CITY PLAN COMMISSION STAFF REPORT

Moss Farm

CD-CPC-2024-00194
Rezoning

CD-CPC-2024-00195
Development Plan - Residential

MOSS FARM
KANSAS CITY, PLATTE COUNTY, MISSOURI
DEVELOPMENT PLAN & PRELIMINARY PLAT
PRELIMINARY PLAT 3 OF 3

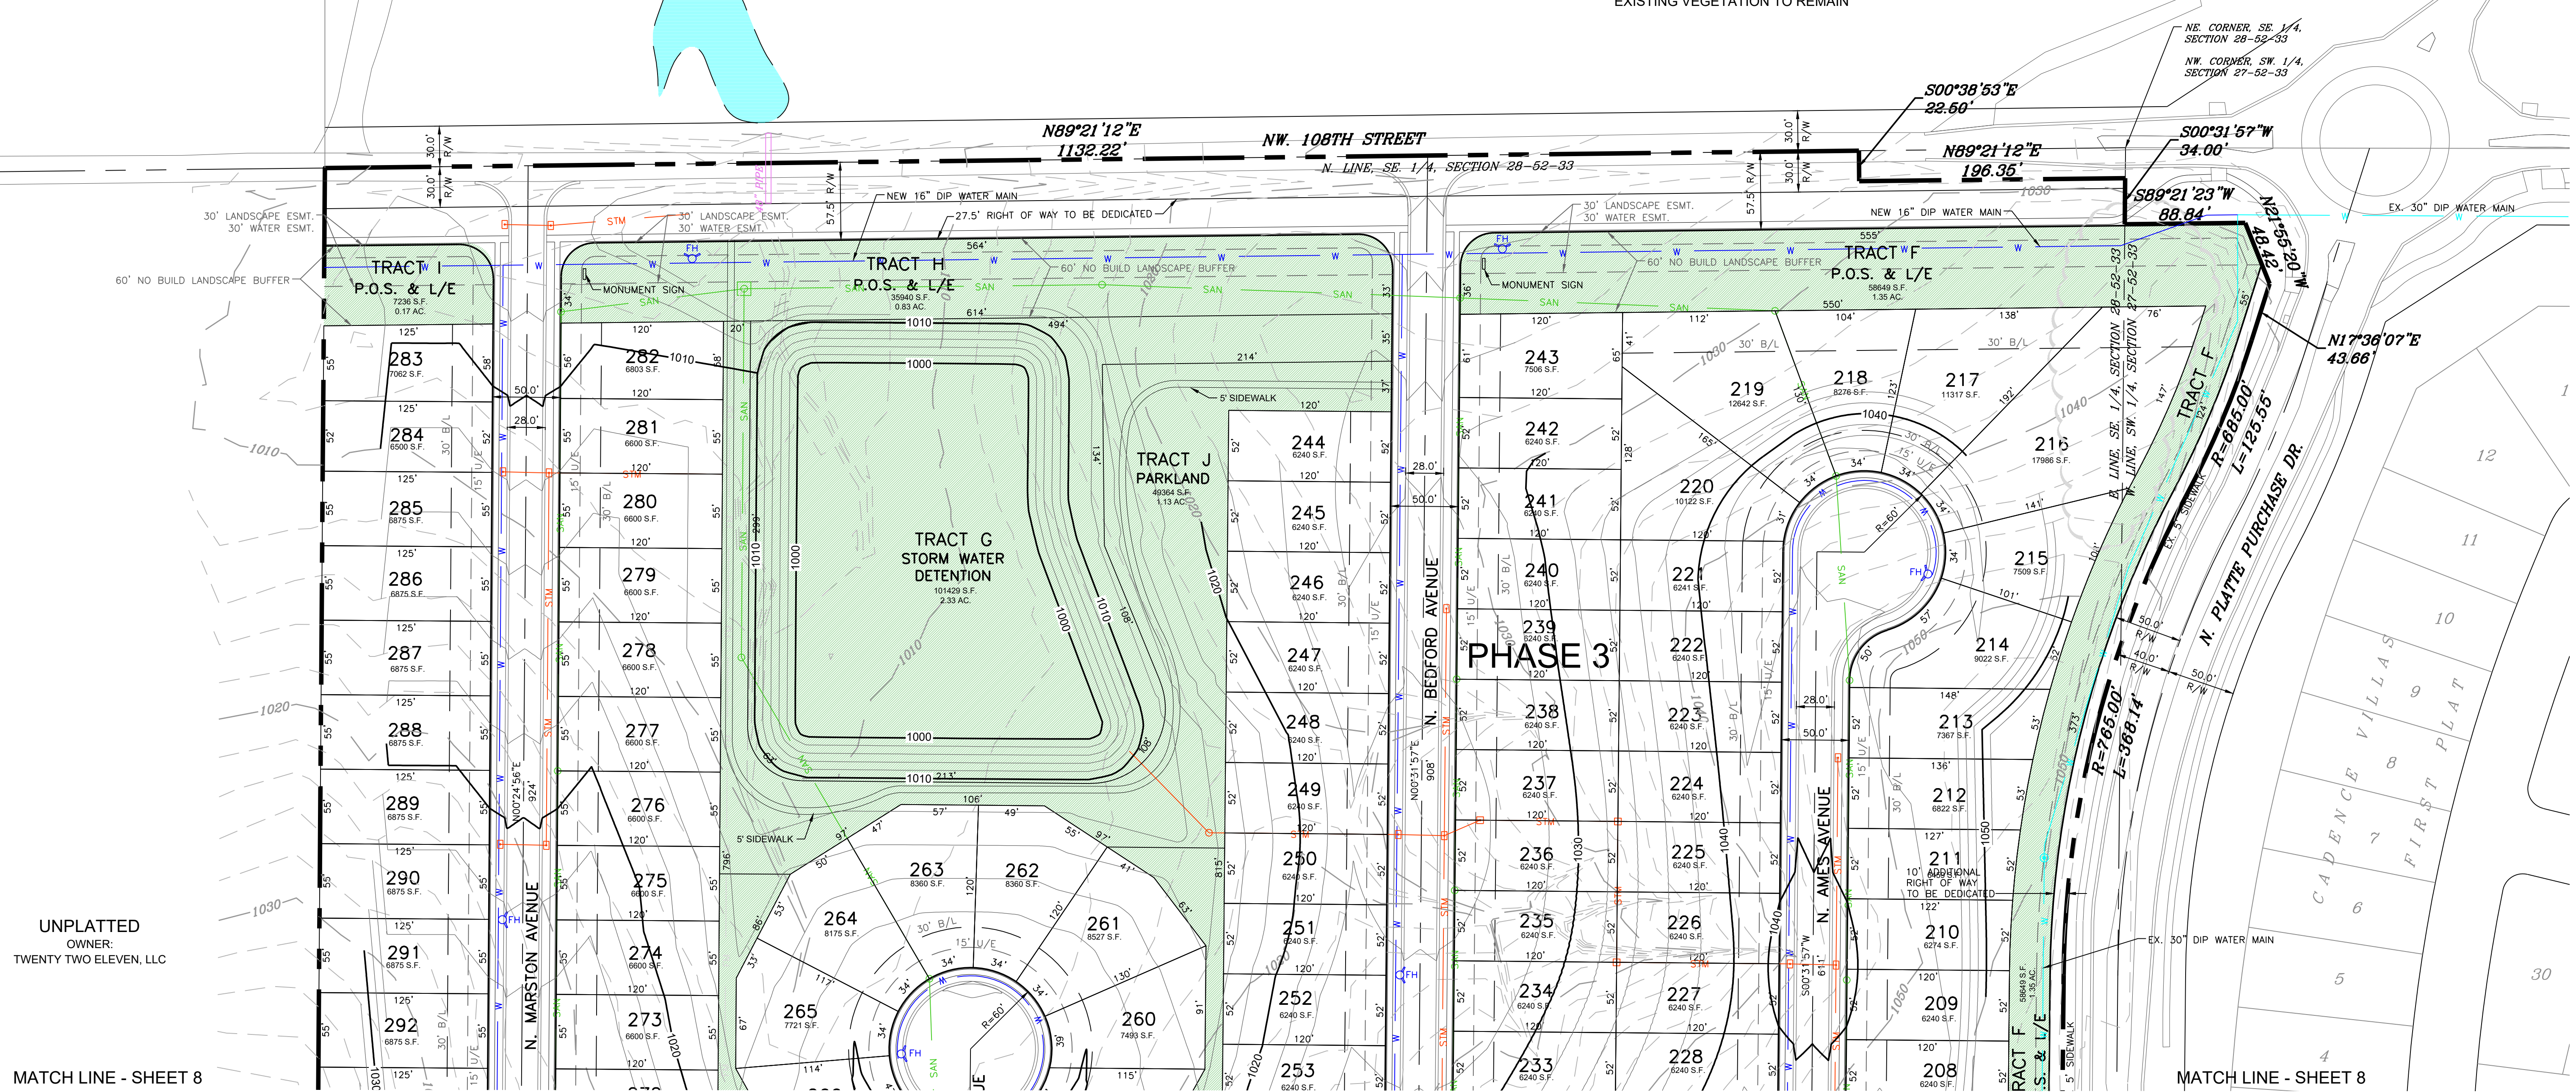
- Provide a sidewalk as well as street trees along 108th as it is a primary image street designated by the KCI area plan. (KCI Area Plan pg. 62)
- Consider connecting the two Eastern most cul-de-sacs as the KCI area plan and the KC Spirit playbook discourage the use of cul-de-sacs (KC Spirit Playbook pg. 349)

MOSS FARM
 KANSAS CITY, PLATTE COUNTY, MISSOURI
 DEVELOPMENT PLAN & PRELIMINARY PLAN
 PRELIMINARY STREETScape PLAN

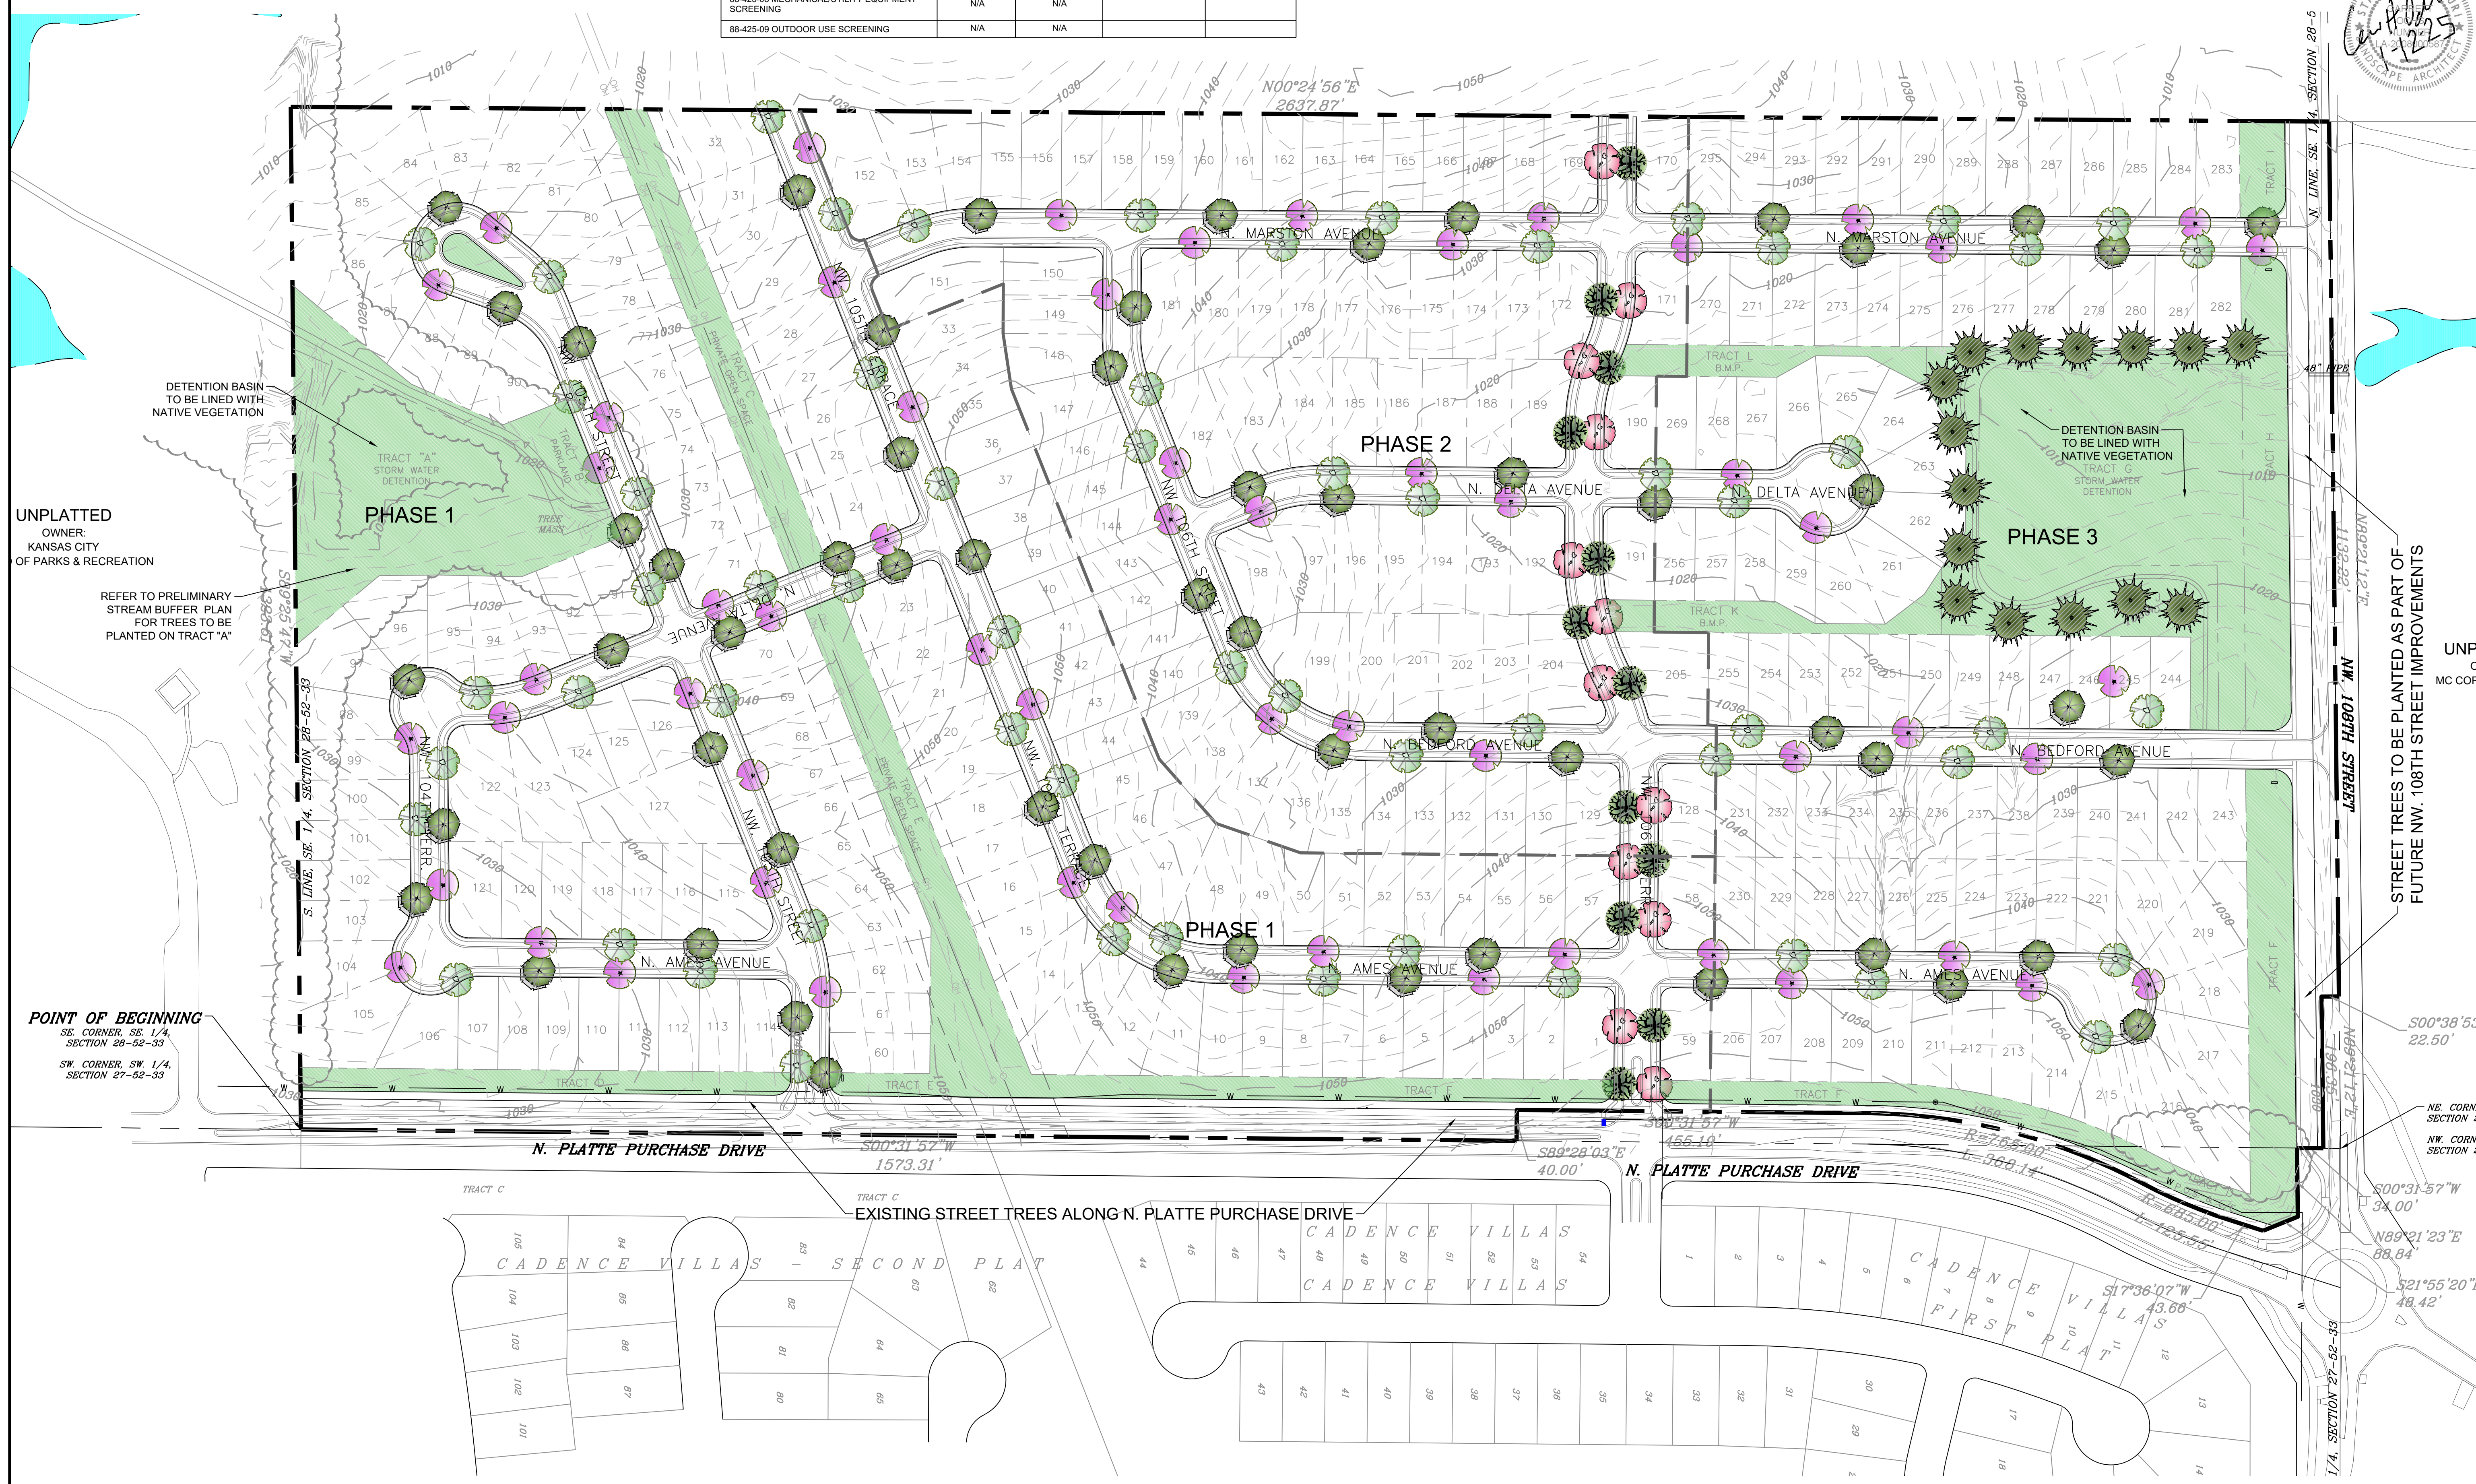
The proposed site would remove pervious surface, however no large vegetation is being lost. There is a regulated stream on the southern portion of the site. Proposed landscaping meets city code however there are no street trees located along 108th st. As a primary image street additional landscaping should be added along 108th as aesthetic enchantments are encouraged along image streets.

MOSS FARM
 KANSAS CITY, PLATTE COUNTY, MISSOURI
 DEVELOPMENT PLAN & PRELIMINARY PLAN
PRELIMINARY STREAM BUFFER PLAN

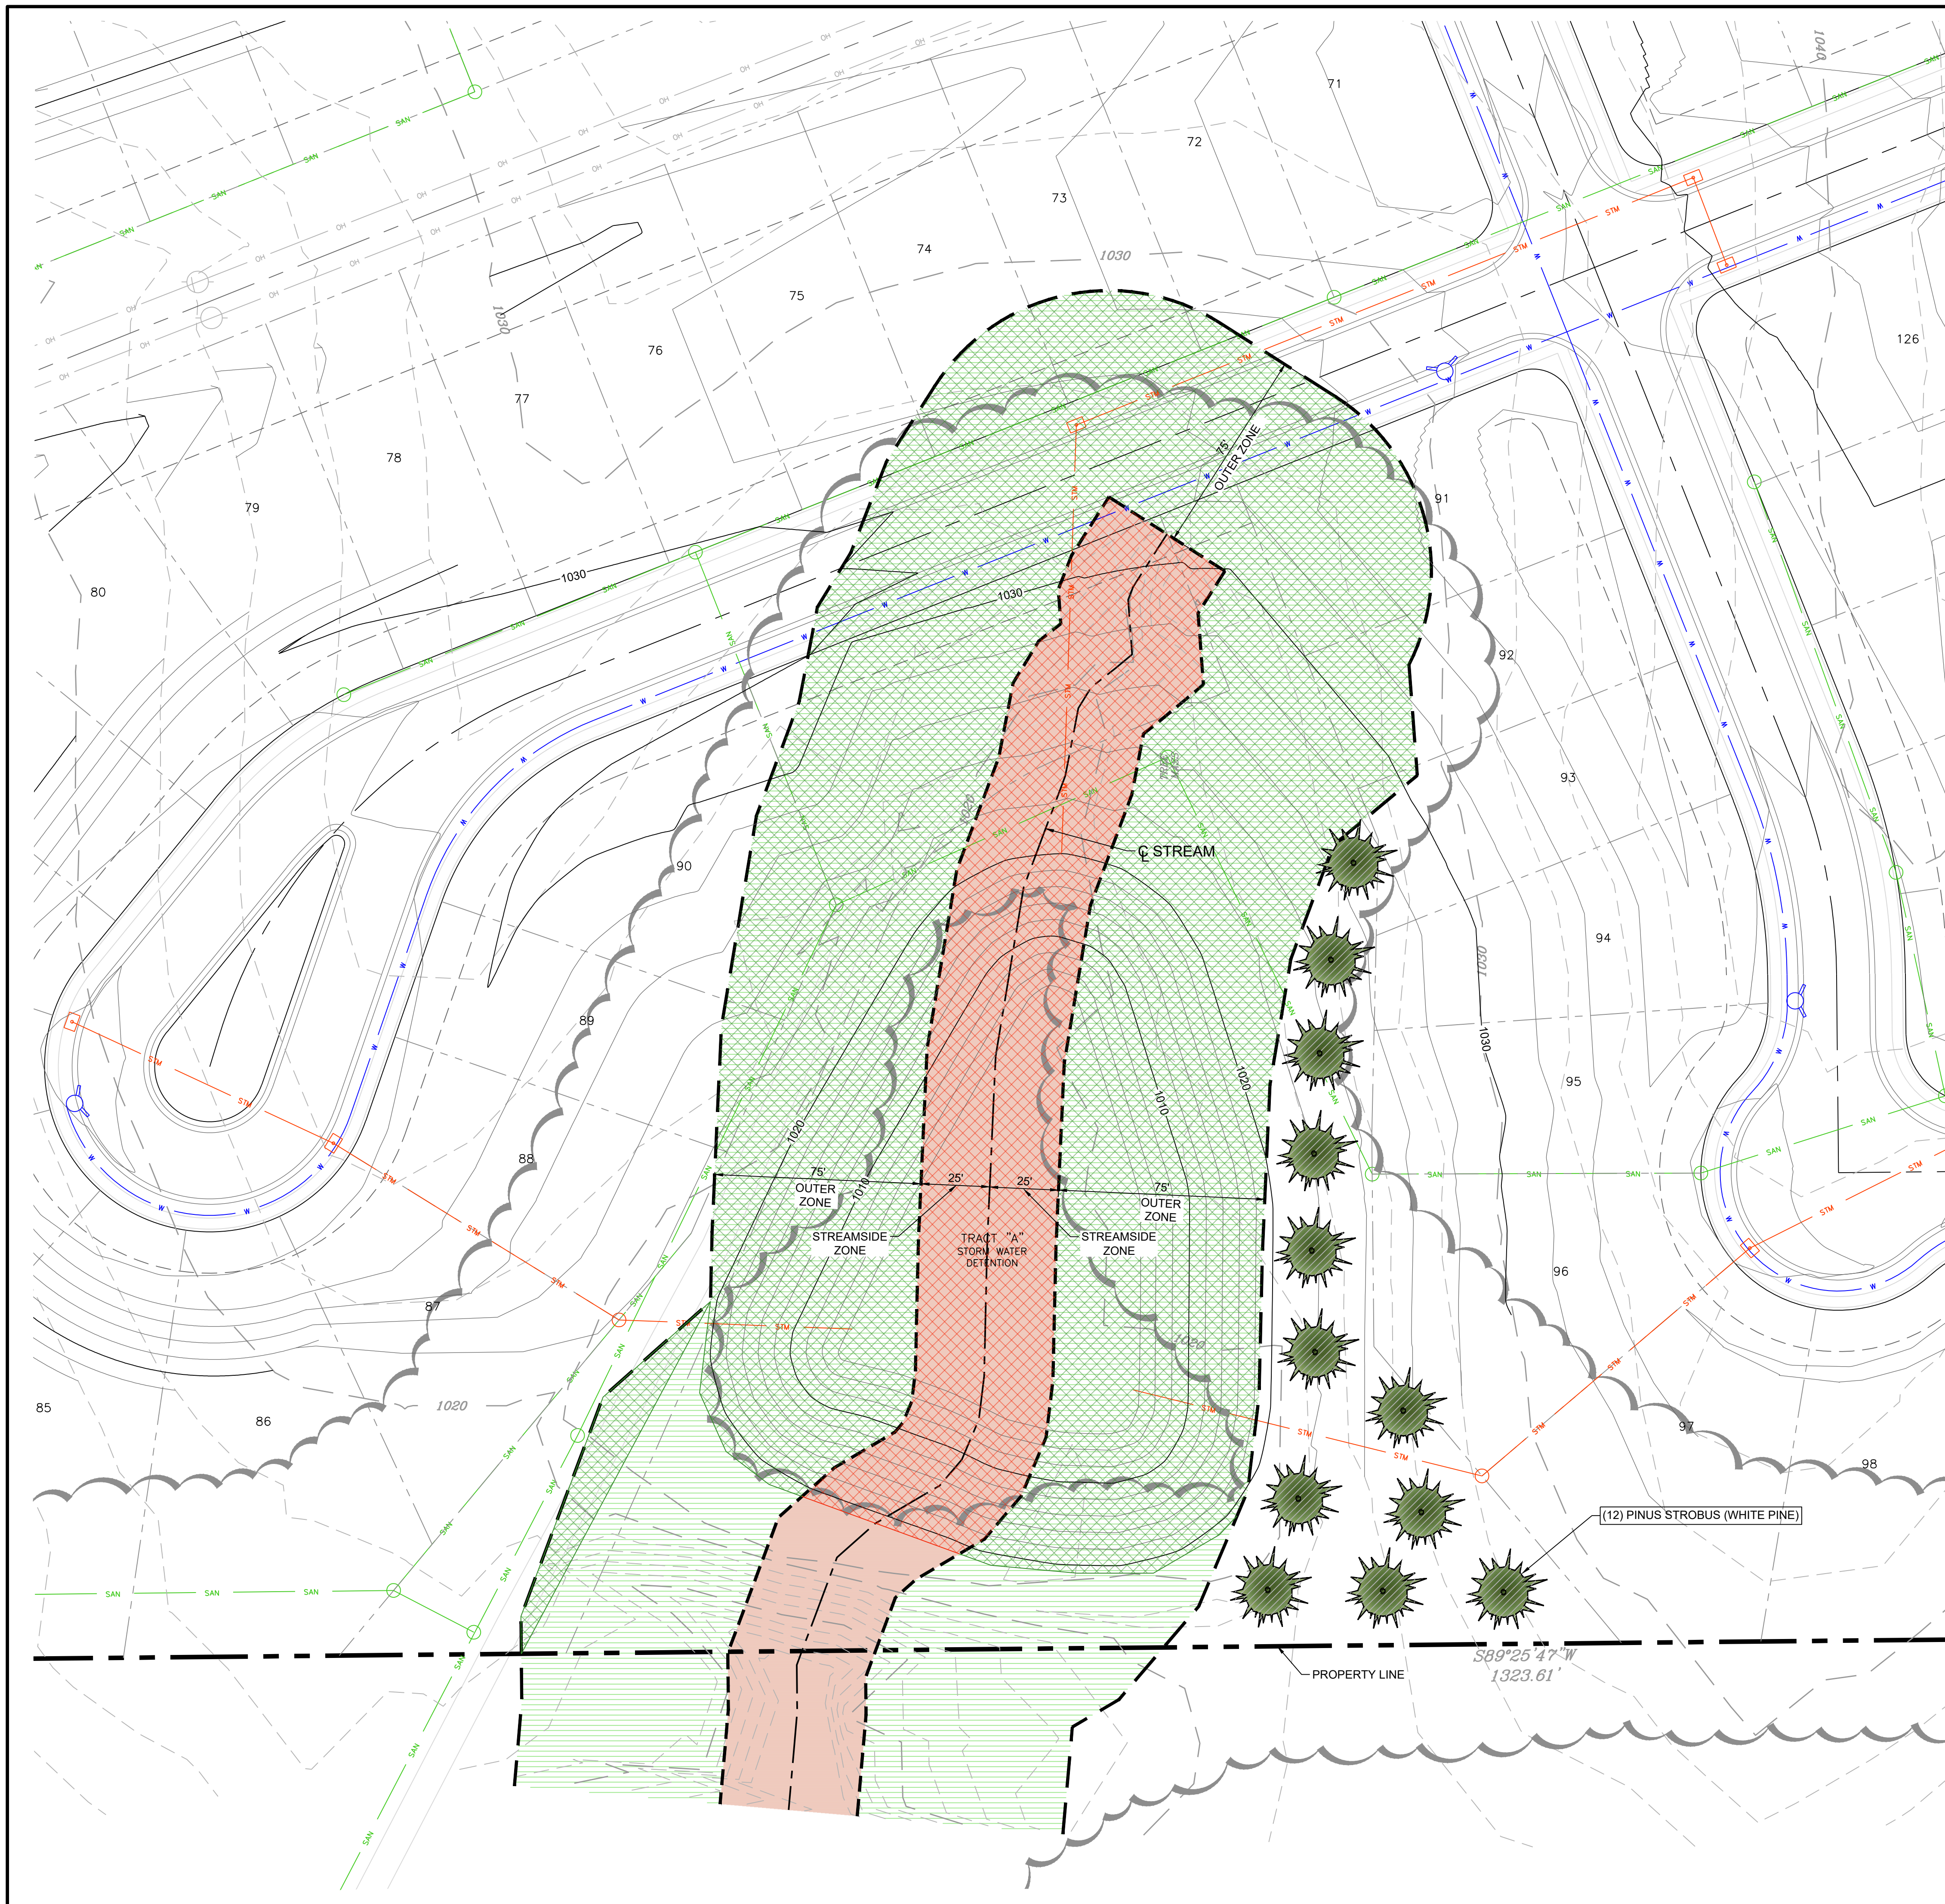
49. The developer shall submit a Preliminary Stream Buffer plan prior to approval of the plan in accordance with the Section 88-415 requirements.
50. The developer must secure permits to extend public sanitary and storm water conveyance systems to serve all proposed lots within the development and determine adequacy of receiving systems as required by KC Water, prior to recording the plat or issuance of a building permit whichever occurs first.
